Overview

The purpose of this notification is to communicate a change in the assembly location for lead frame devices from Amkor Technology Korea (ATK) to Amkor Technology Philippines (ATP). Xilinx's commercial devices have been qualified and in production at ATP for over 10 years. This notification applies to all TQG100, TQG144, VQG44 and VQG100 for Automotive (XA) CoolRunner™-II CPLD family.

Figure 1: Sample Marking for Fabrication Change for XA2C Device in VQG100 Package

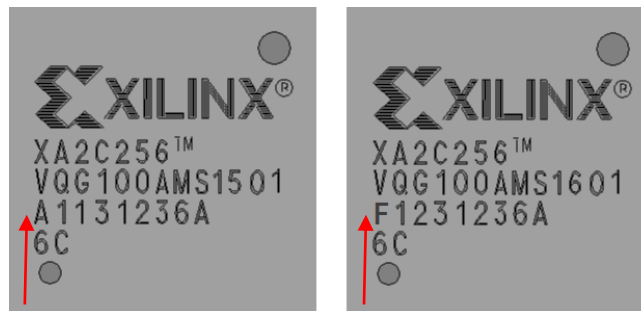
As part of this transition, a minor topside marking will be changed from 'A' to 'F' for the TQG100, TQG144, VQG44 and VQG100 packages. Please refer to [Figure 1](#) below for an illustration of the new topside marking changes.

“A”=Amkor Korea

“F”=Amkor Philippines
